APPLICATION NO.	FILING DATE	FIRST NAMED INVENTOR	ATTORNEY DOCKET NO.	CONFIRMATION NO.
10/560,148	12/07/2005	Ulrich Bantle	VO-740	9460
42419	7590	09/04/2007	EXAMINER	
PAULEY PETERSEN & ERICKSON			GLUCHOWSKI, KRISTINA R	
2800 WEST HIGGINS ROAD			ART UNIT	
SUITE 365			PAPER NUMBER	
HOFFMAN ESTATES, IL 60195			3676	
MAIL DATE	DELIVERY MODE			
09/04/2007	PAPER

Office Action Summary	Application No.	Applicant(s)
	10/560,148	BANTLE, ULRICH
	Examiner Kristina R. Gluchowski	Art Unit 3676

DETAILED ACTION

FIG. 1

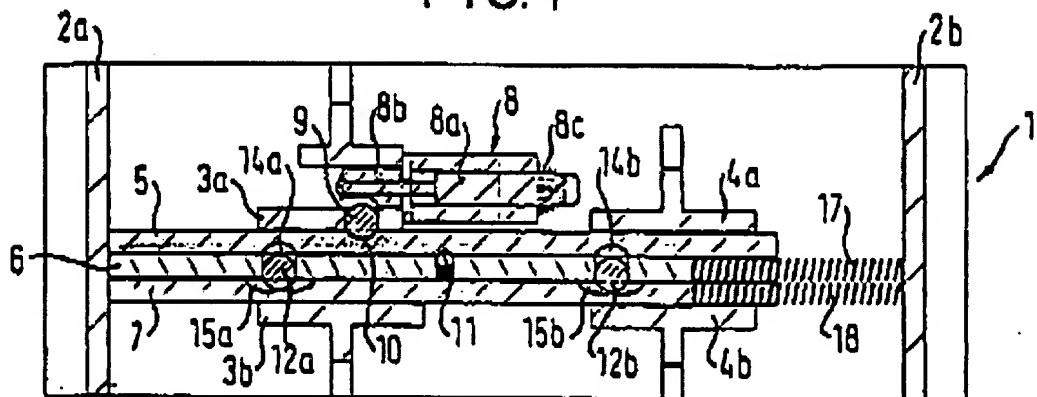
5. Regarding claims 1 and 20-21 Engler shows a lock with a bolt (7, see figures 1 and 6) arranged in a lock housing (1), wherein the bolt can be shifted between an opened position and a closed position by a closing element (5), wherein in the closing position the closing element can be blocked by a blocking element (8b, 9, 10), and the blocking element is coupled with an armature (8a) of an electromagnet (8) and can be actuated by the armature. Engler fails to show a shield for the electromagnet. Goldman shows that it is well known in the art to provide a shield for the electromagnet in addition to the housing. Goldman shows a lock having an electromagnet (65) covered by shield (98) to protect the magnet. Although Goldman fails to specifically describe the material of the shield, it would be obvious to make the shield from a low-retentive magnetic material in order to avoid interference between the shield and the electromagnet. The examiner would like to note that the shield of Goldman is inherently capable of shielding the electromagnet from radiation acting external of the lock housing. Any type of covering of a magnet is considered to shield the magnet from external radiation. It is

6. Regarding claim 2, Engler in view of Goldman, Engler shows the housing having a connecting side (left side of housing, figure 8) on which lock-operating elements (wires, 21) are arranged. Regarding the amended limitation including placement of the shield, it would have been obvious to one of ordinary skill in the art to place the shield of Goldman between the electromagnet and the connecting side of Engler in order to adequately protect the magnet.

FIG. 6

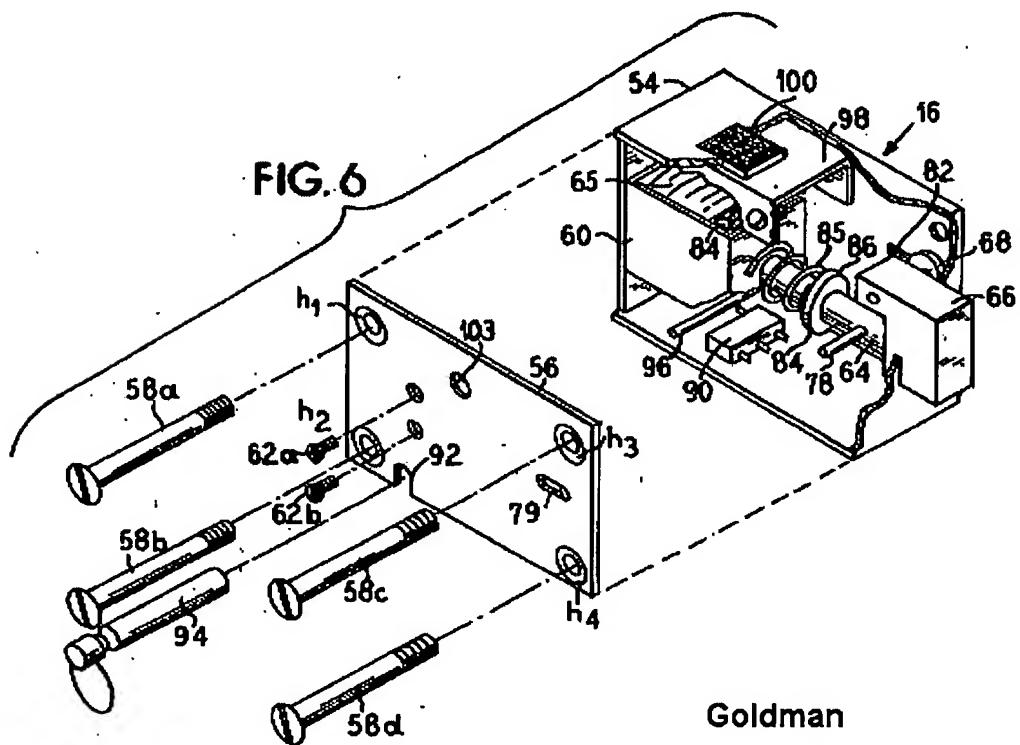
9. Regarding claims 5 and 13, Engler in view of Goldman, Goldman shows three different shields (each side of the U-shape is considered a shield). Although the shields are integral in this instance, they are separable and would function as 3 separate shields therefor, Engler in view of Goldman teaches the electromagnet supports a second shielding element (either side of 98).

10. Regarding claim 17, Engler and Goldman teach a lock housing, a bolt and an electromagnet as applied to claim 1 above. Goldman further shows a control device (control unit, 18) which can be adjusted by a keypad (38) assigned to the magnet in which code information is storable which in case of renewed input and after being checked by the stored code information is used for controlling the magnet. It would have been obvious to one of ordinary skill in the art to include a control device adjusted via keypad on the Engler device in order to provide a more user friendly and secure device.

1. Applicant's arguments filed 6/14/07 have been fully considered but they are not persuasive. Regarding the argument that Goldman teaches a U-shaped channel and not a shield, the examiner respectfully disagrees. Goldman's U-shaped channel covers the magnet and therefore inherently shields the magnet. It is well known to shield magnets using an array of covers. See the rejection above for an example of magnet shielding in Sedley.
